| Project        | <b>IEEE 802.16 Broadband Wireless Access Working Group</b> < <a href="http://ieee802.org/16">http://ieee802.org/16</a> >   |   |
| Title          | <b>Corrections on MS network entry procedures in transparent RS systems</b>  |   |
| Abstract       | This contribution proposes corrections on MS network entry procedures in transparent RS systems.   |   |
| Purpose        | Text proposal for 802.16j Baseline Document.   |   |

Figure 95a—Handle CDMA initial ranging code at transparent RS

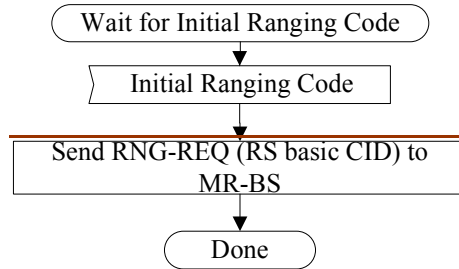
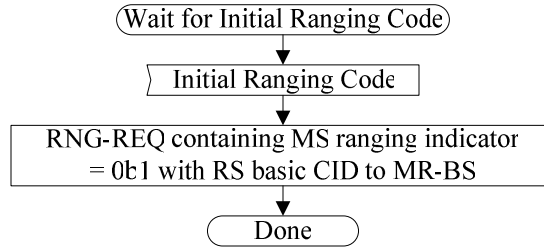
[Replaced the figure 95a in page 80 as following indicated]

Figure 95b—Handle RNG-REQ in transparent RS

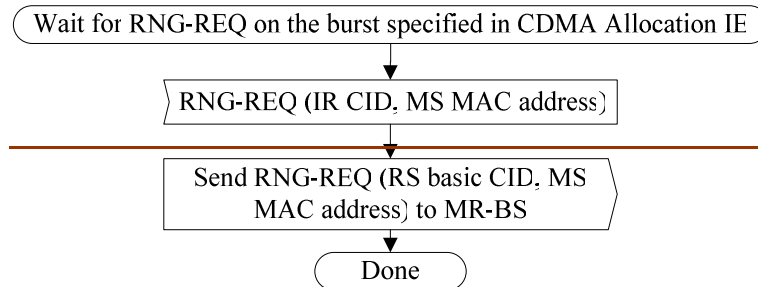
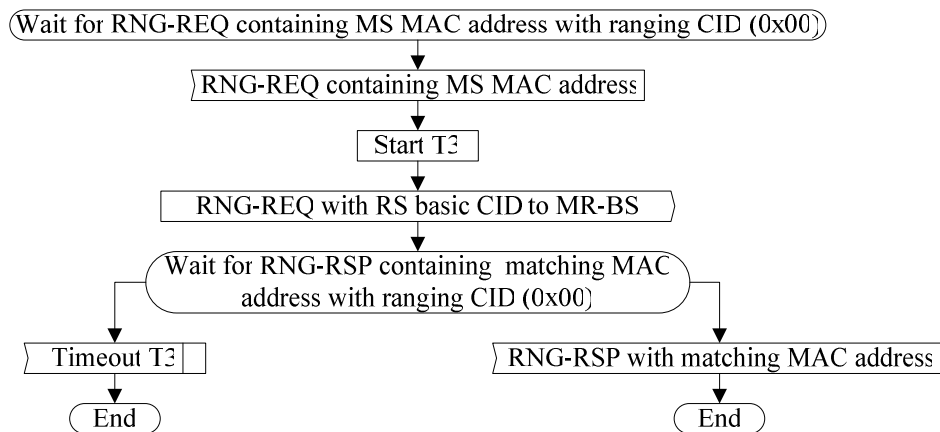
[Replaced the figure 95b in page 80 as following indicated]

Figure 95c—Handle CDMA initial ranging code in transparent mode at MR-BS

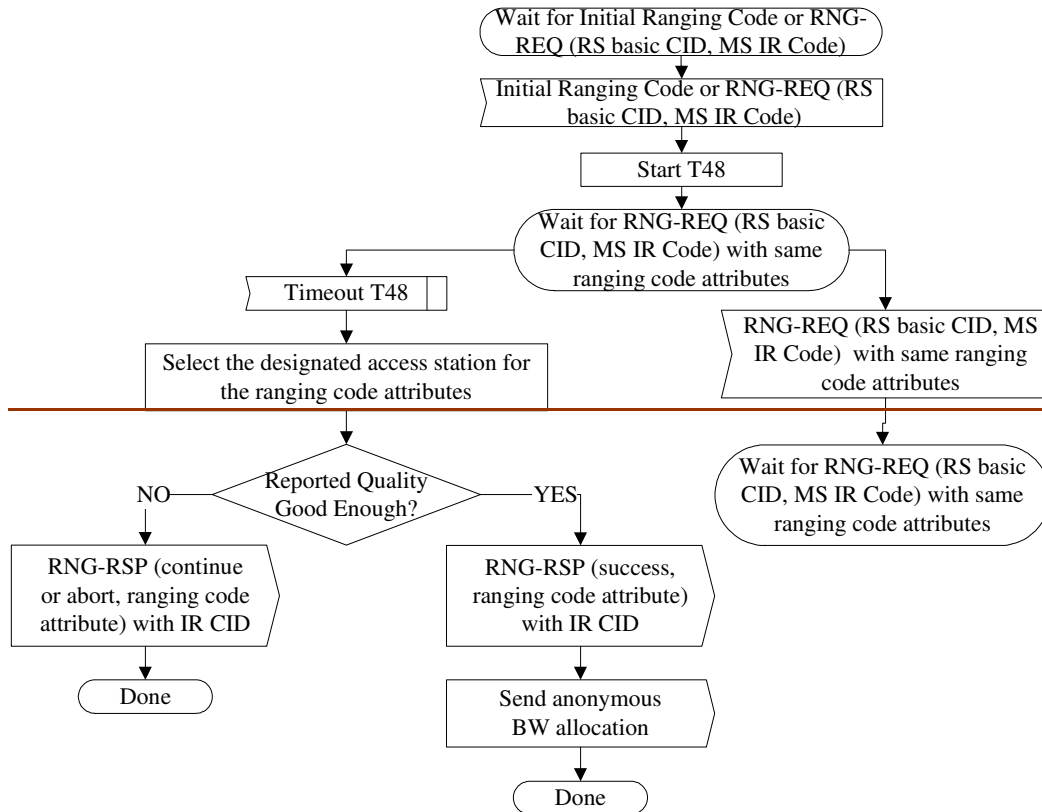
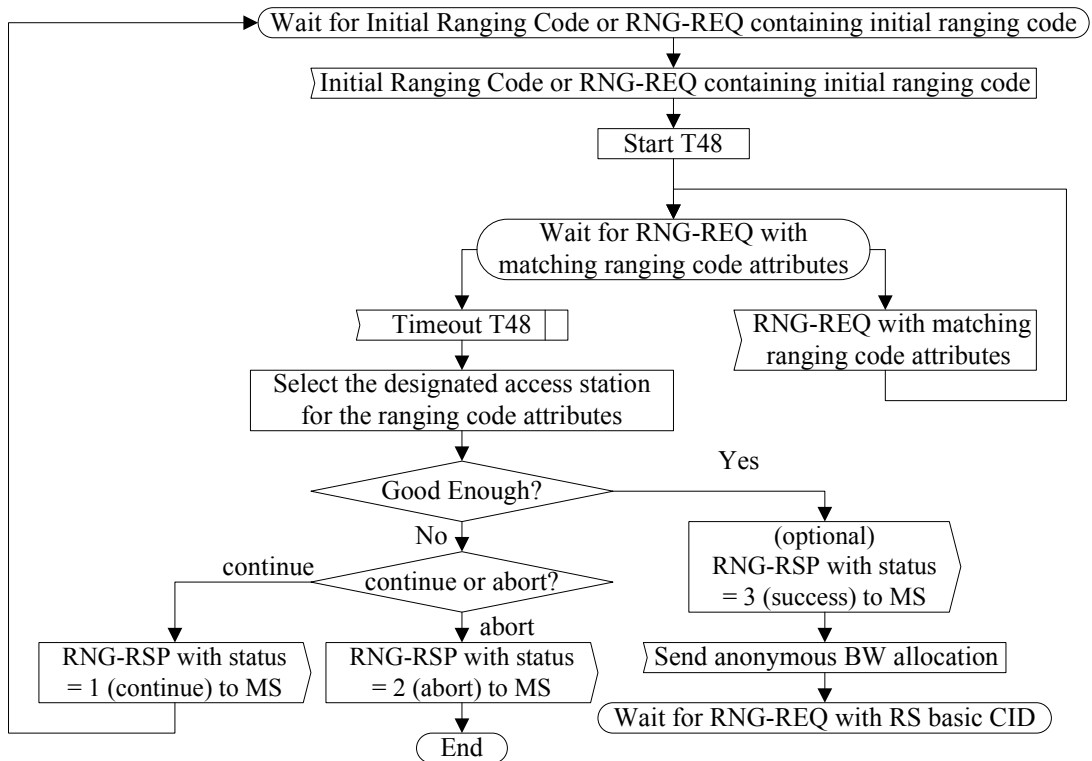
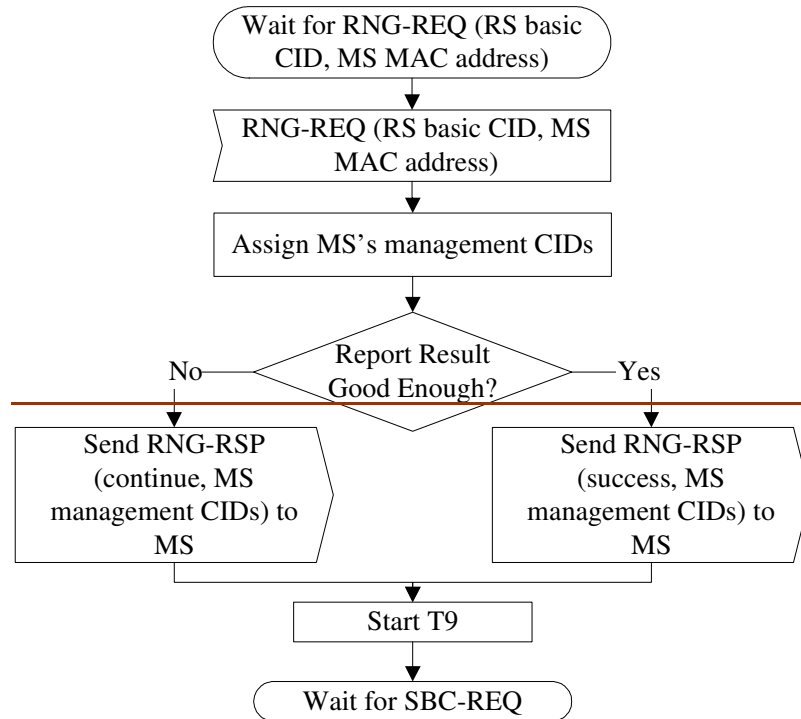
[Replaced the figure 95c in page 81 as following indicated]

Figure 95d—Handle RNG-REQ in transparent mode at MR-BS

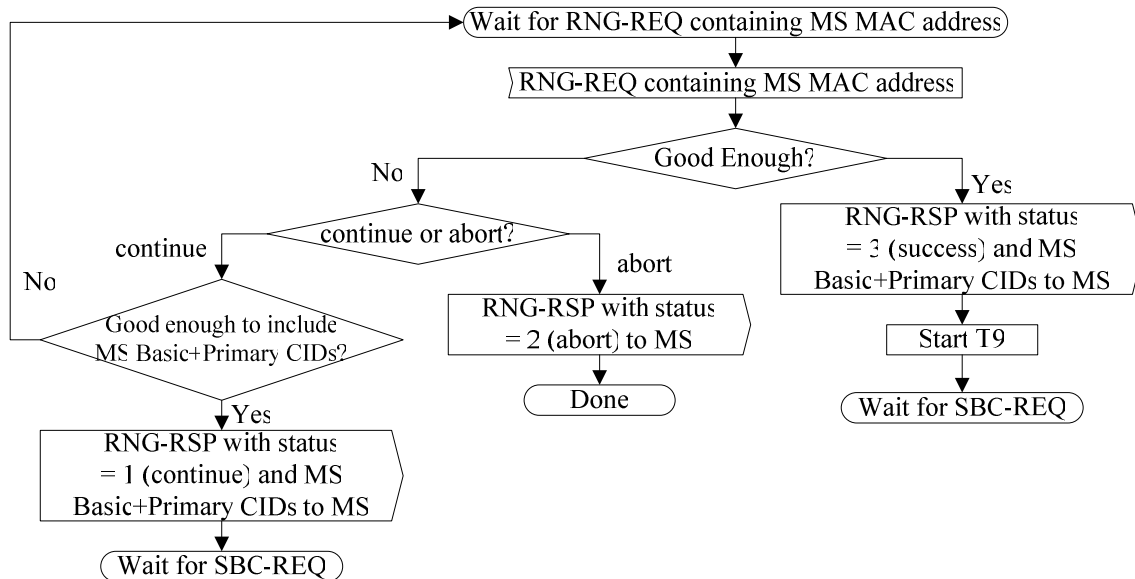
[Replaced the figure 95d in page 82 as following indicated]

Note: T9 is the timer between the MR-BS sending an RNG-RSP to an MS and receiving an SBC-REQ from the same MS
